79-81 Moorabool Street, GEELONG

Planning Permit Assessment
Application No. PA2302387

Officer Assessment Report
Development Approvals & Design

Figure 11. West Elevation view from Moorabool Street and detail of western facade

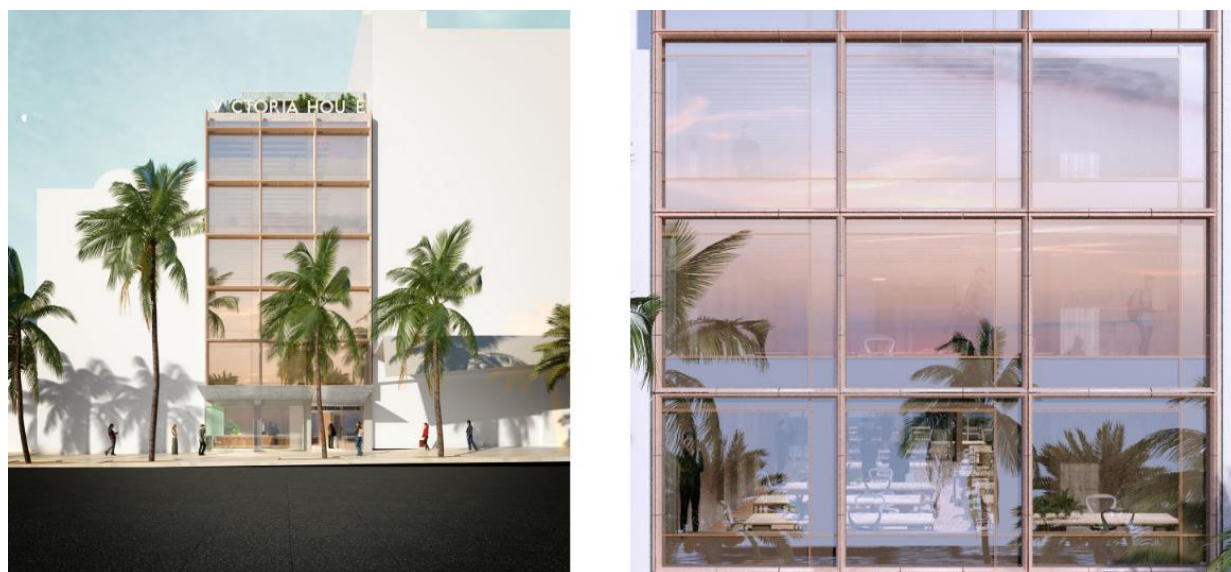
42. The proposal seeks to construct a meeting space and non-trafficable landscaped terrace above the existing primary roof level. This takes the building from six (6) storeys to seven (7), however the seventh floor will remain under the existing building height due to the height of the existing roof plant. There is therefore no increase to overall building height.
43. The existing building extends to a maximum height of 25.4m, the top of the parapet of the proposed meeting room is to sit at 22.59m.
44. Although the proposal will continue to sit above the recommended building height within the ACZ1 of 21 metres, the proposed addition is set back from the north, east and western façades, is to be majority glazing and it is to sit behind

landscaping at the rooftop terrace. This ensures the additional built form is recessive and not visually dominant when viewed from Moorabool Street (figure 11).

Figure 12. Existing and proposed massing

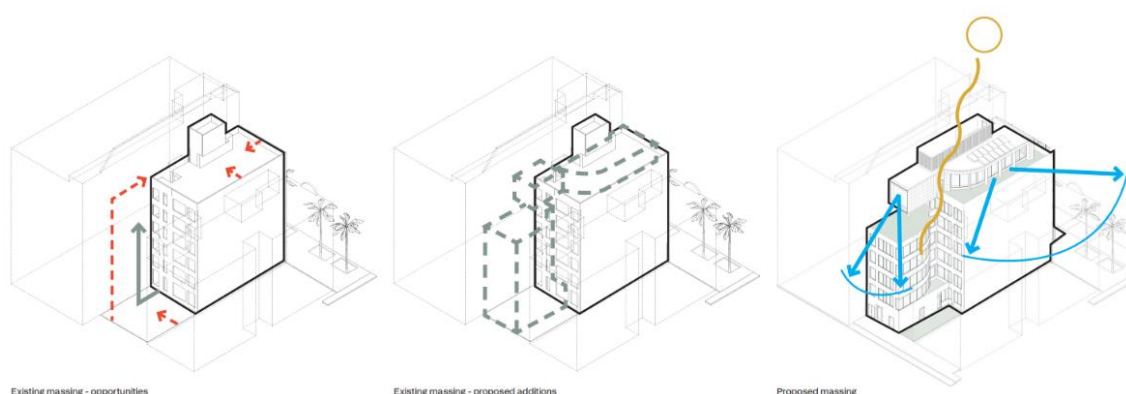
The mass situated to the rear is setback from the north and shaped where it meets the old building to maximise daylight to the floorplates.

At level 5 an external terrace breaks the building mass and creates vertical separation from a feature meeting pod that protrudes over. Level 6 introduces a dedicated meeting space that is setback from Moorabool St and the north, with a primary outlook north over the bay (figure 12).

Figure 13. Equitable development ACZ1 requirement (left) and matching built form (right)

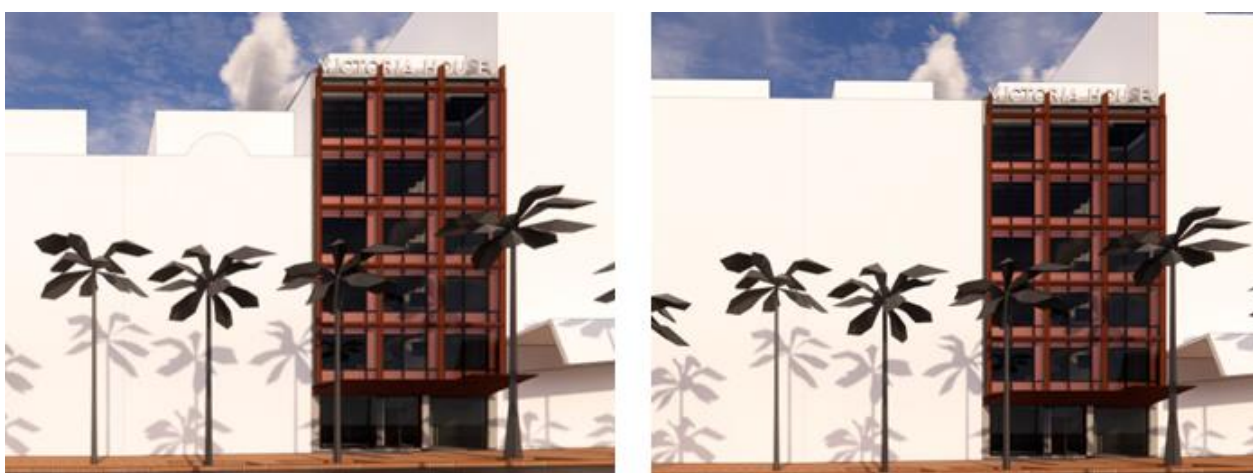
48. The initial proposal sought a 1m upper side back on the northern boundary of which CoGG requested that the upper side setback be increased to the full 4.5m (as recommended under the ACZ1 discretionary requirement. As) existing built form is approximately only 10m wide, DTP considered a full 4.5m upper side setback at level 7 was an unreasonable request to implement to achieve a functional floorplate at that level. Instead, a 3m setback was requested under Section 50A Amendment.

49. The applicant provided the Section 50A amended plans on 20 November 2023 with a number of positive changes and a 2.75m setback rather than the requested 3m at level 7 (meeting space). The applicant provided extensive justification and 3D streetscape perspectives that satisfactorily displayed the negligible streetscape impact and equitable development outcomes for the abutting property to the north (75-77 Moorabool Street) against matching street wall heights and ACZ1 requirement scenarios (figure 13 & 14.)

Figure 18. Proposed West Elevation – Floodlit sky sign

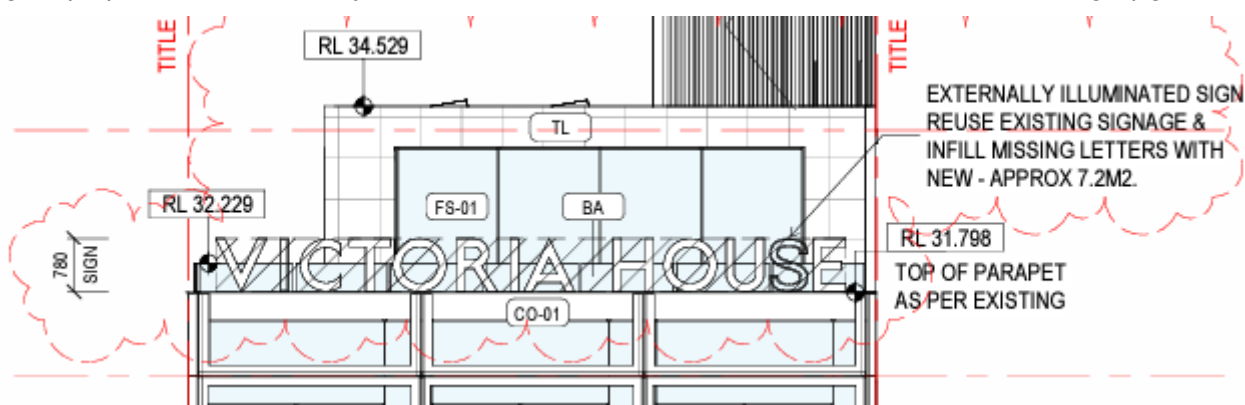
There are no specific requirements under Clause 52.05-11 relating to sky signs. It is however noted that the sky sign is proposed to be externally illuminated and is therefore also considered to be a floodlit sign (figure 18).

73. The retention and reuse of the Victoria House (sky) sign is considered favourable as it pays homage to the existing and surrounding built context. The sky sign is proposed to be externally illuminated. While the placement of the external lights sources is yet to be determined, due to the location of the sign being above the street wall, the external lighting will not result in amenity impacts on the adjoining properties, with the light spill being limited to the site. Conditions will be placed onto the permit for the applicant to provide further details of the external light sources, including placement, luminosity and light spill.

Figure 19. Proposed west elevation – ground floor signage

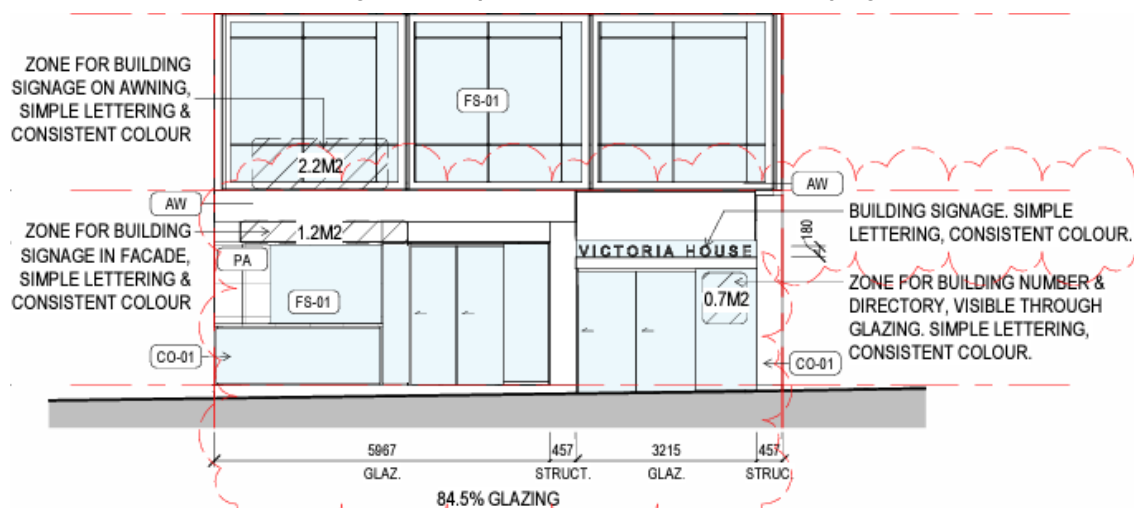
70. Indicative business identification signage is shown at the lower levels of the western façade to demonstrate potential signage locations for future tenants (Figure 19).
